Spartan Fire, LLC

Technical Service Bulletin
TSB26-270-001

APPLIES TO: This service bulletin applies to certain model year 2022-2026 Gladiator and Metro Star, 2022-2026 FC-94, 2024-2026 KME Panther, and 2024-2025 KME Predator model emergency response chassis cabs built between November 2022 and January 2026.

CONDITION: Certain coolant level sensors may incorrectly activate a low coolant level alarm and fault code when the coolant is in fact full.

Figure 2.1

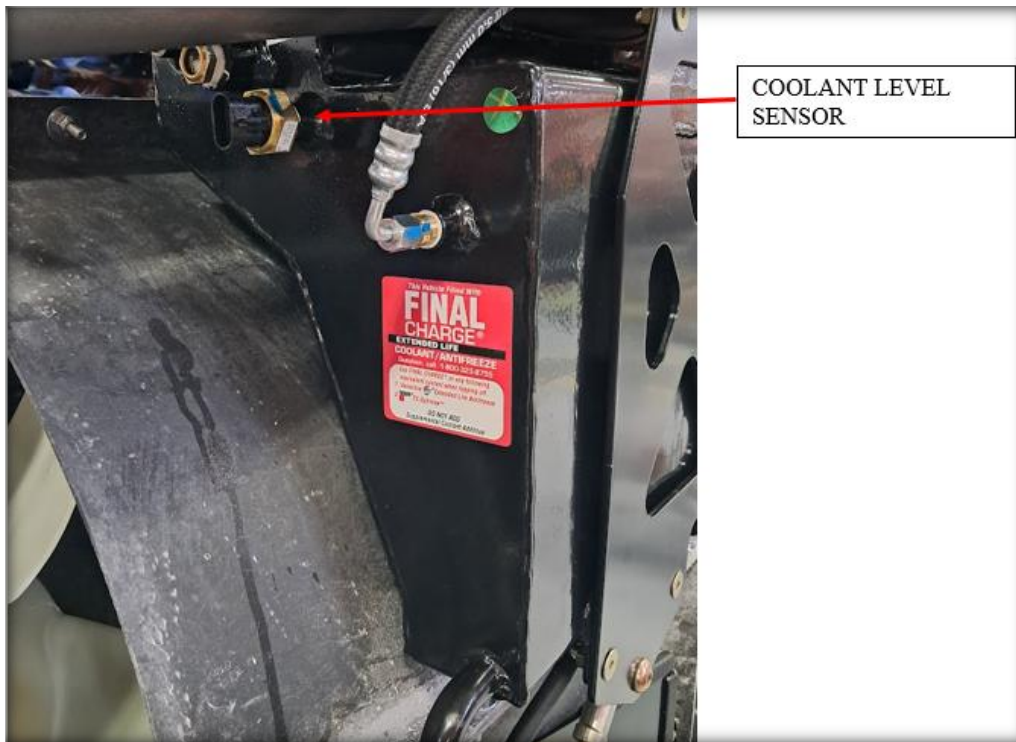
- 1) With the master switch on, ignition off, tilt the cab up until the yellow lock bar falls into place on the tilt cylinder.
- 2) Drain 1-2 gallons from the radiator to lower the coolant level to bring the level down below the coolant level sensor port that is welded to the surge tank
- 3) Locate the coolant level sensor on the coolant surge tank on the right side of the coolant package.
- 4) Remove the coolant level sensor from the surge tank and dispose of sensor. (see figure 2.1)
